CONCLUSIONS AND SUGGESTIONS AFTER EEP-VCF STAFF VISIT AT THE PARC DES OISEAUX

Following the proposal from Parc des Oiseaux to participate in the Bearded Vulture EEP network, it was accorded between Le Parc des Oiseaux and EEP/VCF to invite Alex Llopis to visit the Parc, and have a look for the possibilities to house a pair of Bearded Vultures in their facilities.

Picture 6: In red section planned for the Bearded Vulture.

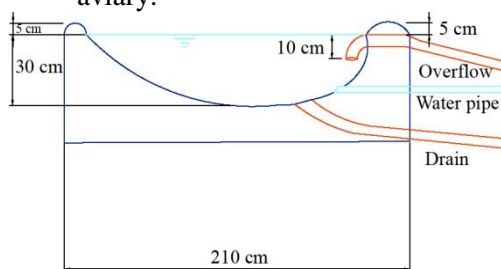
The proposal from the Parc to divide the aviary in two was exhaustively analysed. The idea was to use the west part (sunny part) for the potential Bearded Vulture pair (picture 6).

- Build a fence and the necessary structure for divide the aviary in two. Additional the necessary fittings for assure the physical separation with the neighbour species without obstructing sunshine.

- *Change the whole mesh for a smaller one (max. 10 x 5cm) for avoiding any accidents by collision with the fence. By using mesh size bigger than 2.5 x 2.5cm it will be necessary to install additionally the necessary measures for preventing the entry of small carnivores.*

- *Bearded Vultures as cliff breeders use small caves in the wild (90-120cm height), and well protected from bad climatology. It will be necessary to reduce the height of the caves (potential nest-sites) and enlarge the stone plates which are used as roof for assuring that the nest will be always dry. Is well known that Bearded Vultures by wet nest normally abandon the clutch.*

- *Bearded Vultures are soaring birds of prey and for landing need open and clean ground. To prevent accidents by landing it is important almost all the vegetation inside the aviary to remove. These are obstacles that by other facilities have already caused the loss of several individuals.*

- *Bearded Vultures are very sensitive during the breeding season. For assuring a good breeding success is important to offer the tranquillity required by the species. By installing visitor observatories, stress is minimised for the birds and the probability of injuries caused by flying into the sides is reduced. Aviary size can also be reduced.*

- *To avoid birds flying into the mesh, when they are disturbed or when they become violent (e.g. during attacks or when handling is taking place in the aviary), is very important to install perches throughout the aviary. Additionally this gives them the possibility to move around the cage without getting on the ground, especially when the nest must be controlled by the keepers.*

- *Build a second drinking pool and a mud bath.*
- *etc.*

Finally was decided not to use the common Vultures aviary for house additionally a Bearded Vulture pair and construct a new aviary.

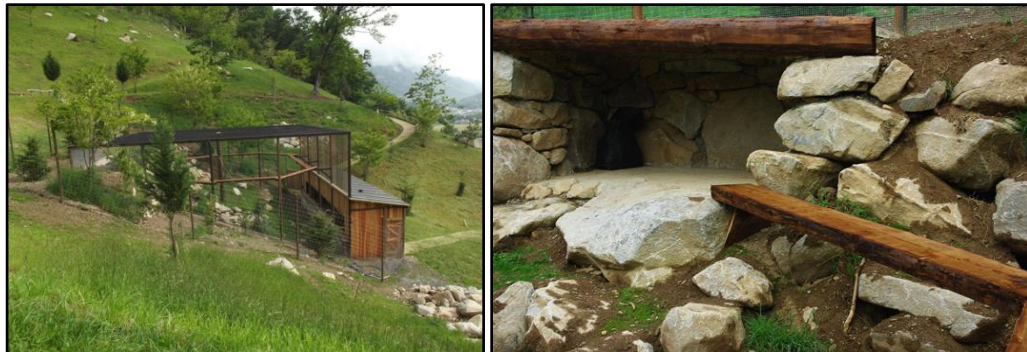
- The Parc is located in a humid area, with a very wet ground. As Bearded Vultures are very sensitive to humidity (risk of aspergillosis), is recommended to **build a slope with stones and stones plates** like the common Vultures aviary. This **will reduce the humidity in the surface** and will give the birds better housing conditions. Further the structure of this slope will give the visitors an adequate picture of the natural habitat of the Bearded Vulture.

- The **slope allows nest monitoring by staff** and gives the **birds facility to climb** to the nest with food and nest material.
- The **nest** should be installed on the **top of the aviary** in a cave at the west side and open to the south. To prevent that birds can walk above the cave, the **roof of the aviary** should start from the **same level as the roof from the cave**. Install minimum 2 caves.

- Nonetheless to avoid injuries on the claws by landing on the floor is recommended the **first 5m be covered with grass**. A drinking pool and mud bath should be installed in this area.

- All birds of prey drink and bath regularly. And especially during egg formation, females drink large quantities of water. **Install a drinking pool in the grass area**. This should have a soft access ramp and be big enough to allow the birds to bathe (210 x 130cm wide and 30-35cm deep). Is recommended to install a **mechanism that allows the drinking bowl to be regulated from outside the aviary**, avoids any disturbances by entering in the aviary during the breeding season. A **closed current water system with filters**, like an artificial river ending with a basin (see common Vulture aviary) or a waterfall helps to maintain the water clean and reduce the necessity to enter in the aviary.

- Bearded Vultures develop the peculiar habit of bathing in mud rich in iron oxide. Although the reason for this behaviour is still unknown, they must be kept in captivity in good physical and psychological condition, offering them all available means of developing as many innate behavioural patterns as possible. Therefore it is recommended to **install a mud bath in the grass area** where mud rich in iron oxide can be provided every 15 days (1m in diameter, and 10cm deep). Use only mud **free of any toxic substances** (heavy metals or other organic contaminants).
